UNITED STATES
NUCLEAR REGULATORY COMMISSION
WASHINGTON, D. C. 20555

RESPONSE TO RG&E COMMENTS ON NRC AUGUST 17, 1978 LETTER

SAFETY EVALUATION REPORT

R. E. GINNA NUCLEAR POWER PLANT UNIT NO. 1

FIGURE IV.2-1
NOVEMBER 1, 1974

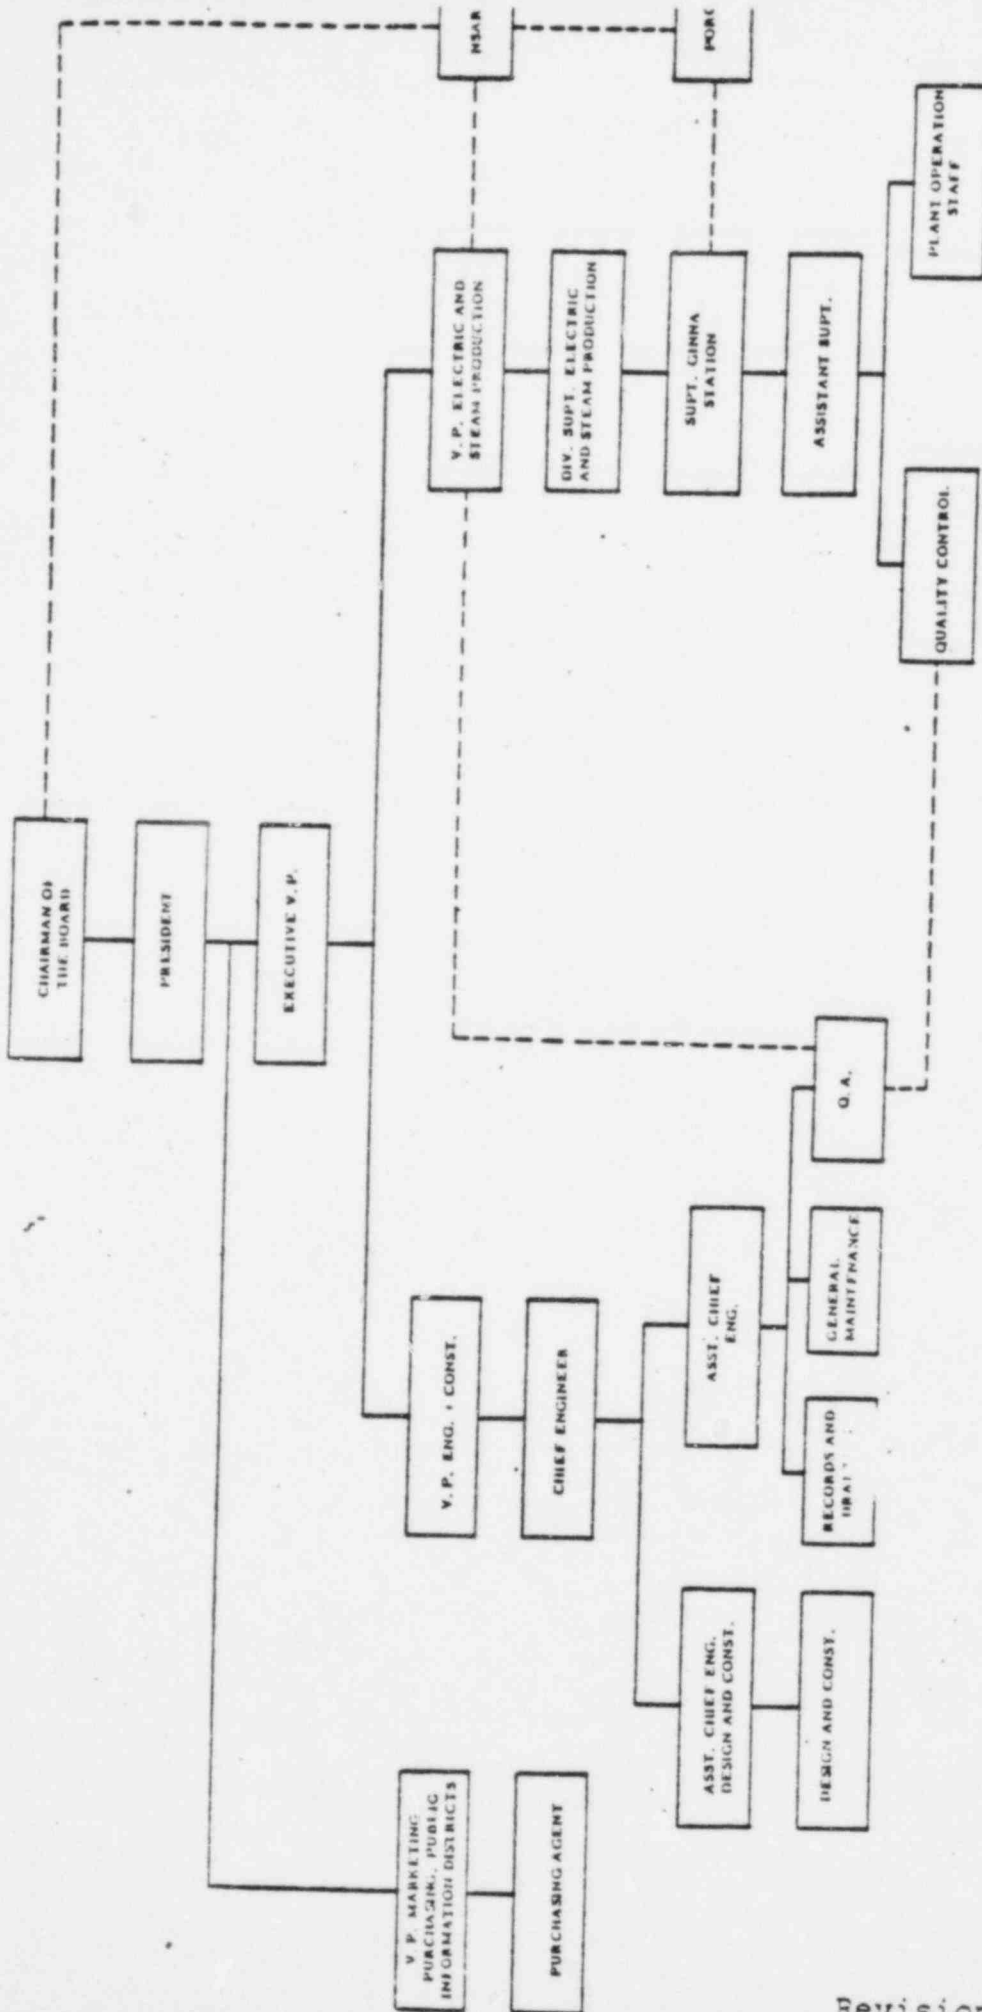
The major RG&E organizations participating in the quality assurance program are Purchasing, Engineering, Electric and Steam Production, Plant Operations Review Committee and Nuclear Safety Audit and Review Board. Figure IV.2-1 shows these organizations and their relationship to the corporate organization. Figures IV.2-2 thru 5 shows a more detailed breakdown of the Quality Assurance, Station Superintendent, Quality Control, and Engineering organizations.

Figure IV. 2-3
 July 1, 1974

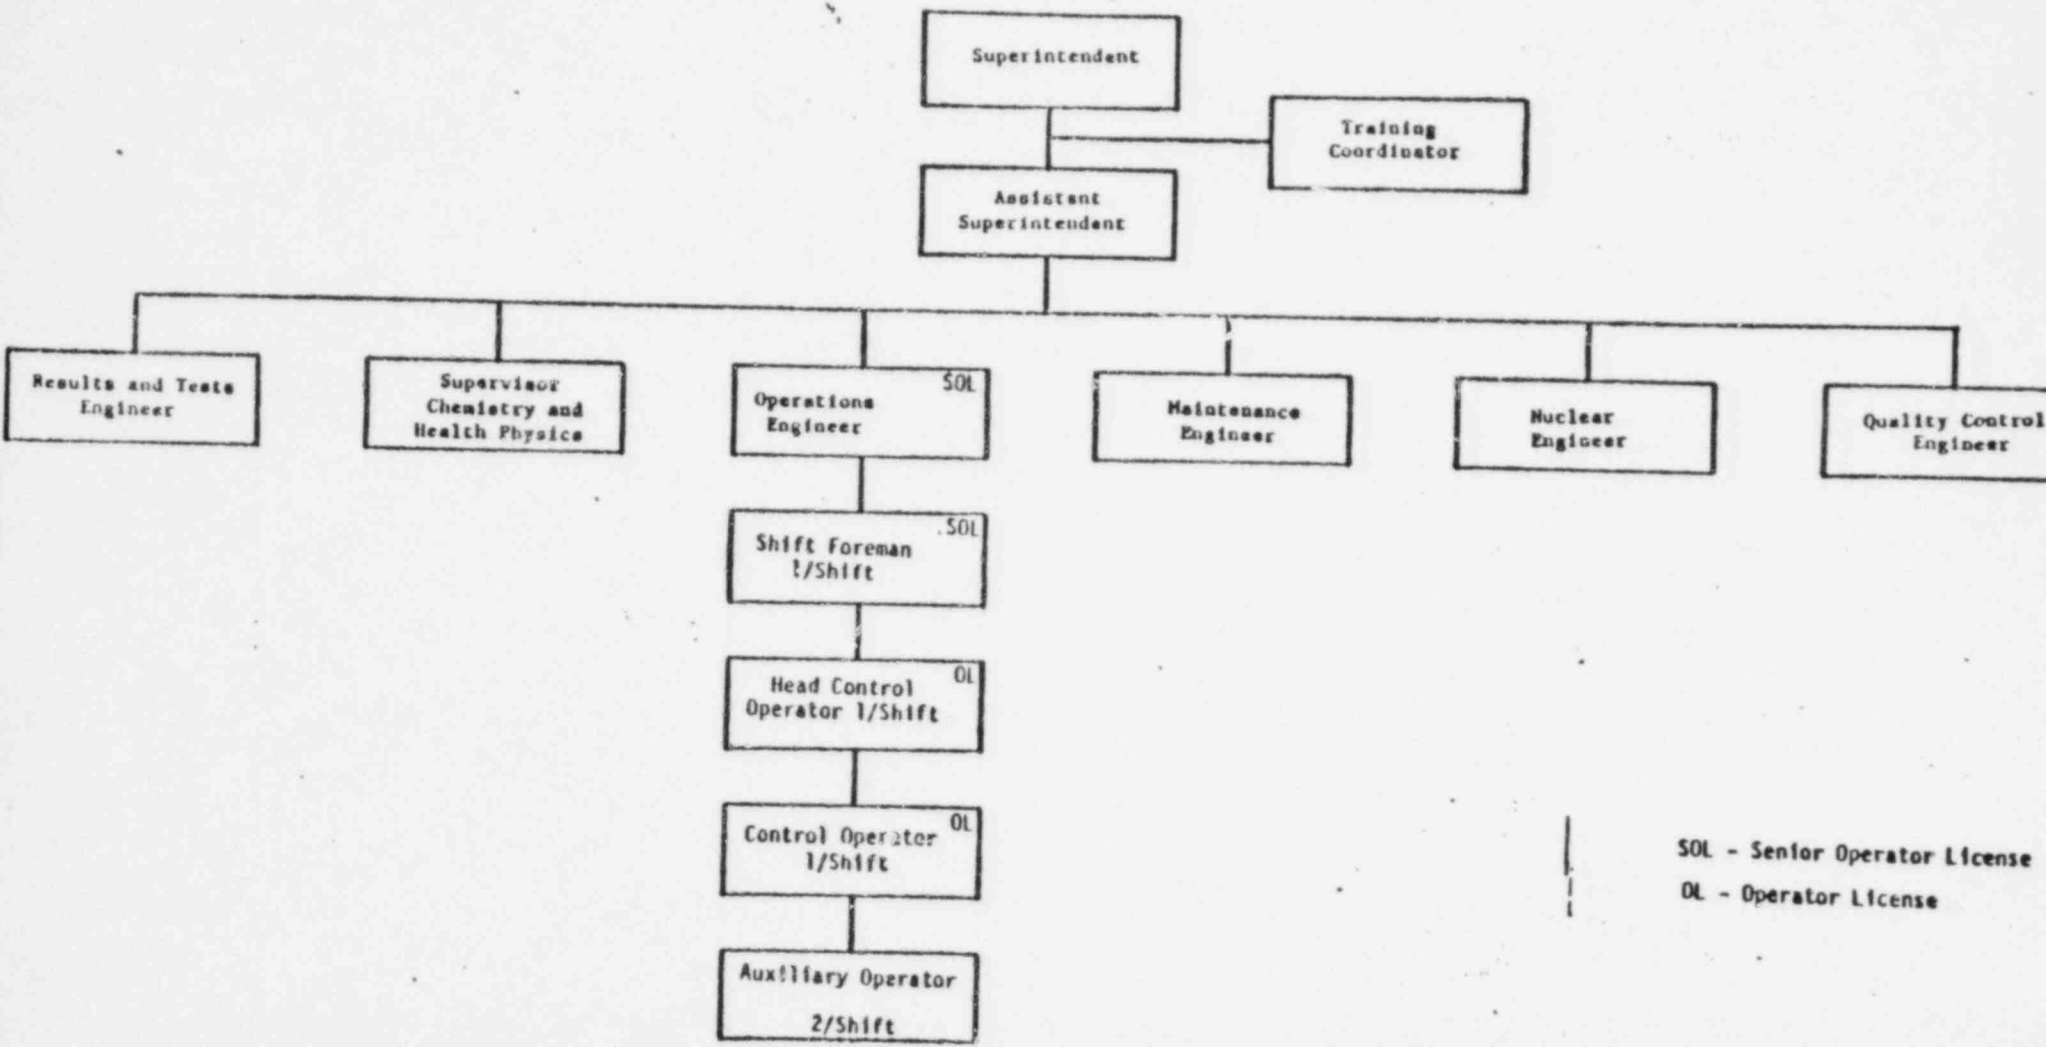
The Ginna Station Superintendent is responsible for the operation, maintenance, repair, refueling, and modification of Ginna Station in accordance with the requirements of the quality assurance program. The Ginna Station Superintendent has reporting to him, on the same organizational level as the other organizational groups of the Superintendent's staff, the Quality Control Engineer (See Figure IV.2-3).

Figure IV.2-4

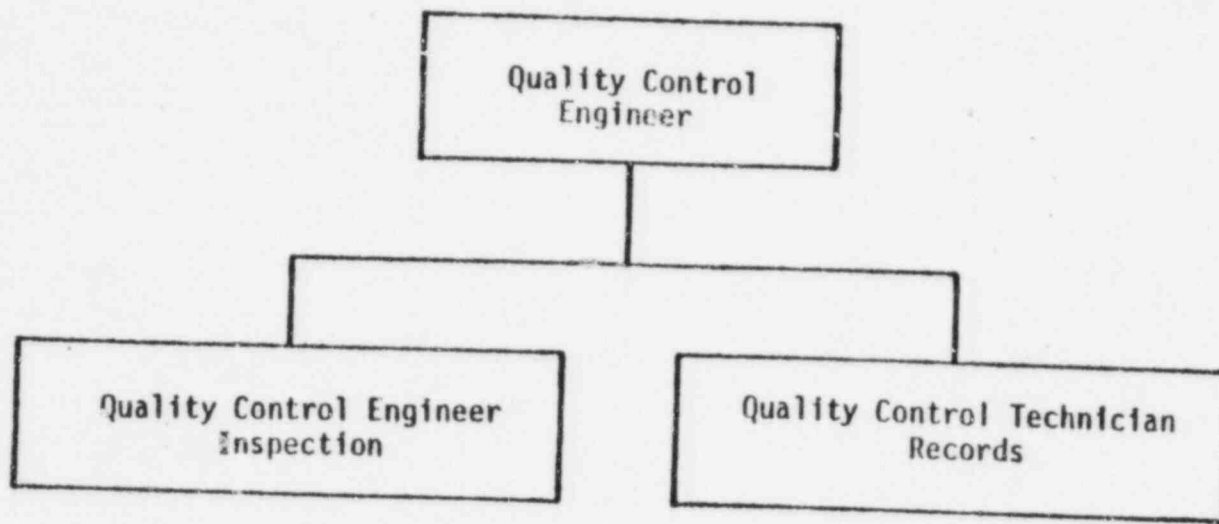
The QC Engineer is responsible to the Station Superintendent for assuring that activities affecting quality are prescribed and carried out in accordance with approved drawings, specifications, and procedures. He is assisted in his duties by a permanent staff as shown on Figure IV.2-4, and such additional inspectors as are required by the level of work activities. The QC Engineer reviews procurement documents initiated at the plant; is responsible for the control of documents and records stored at the plant; coordinates inspection activities and assures that inspection requirements are included in approved procedures; coordinates the receipt inspection of incoming materials, parts, and components, and the processing of material deficiency reports;
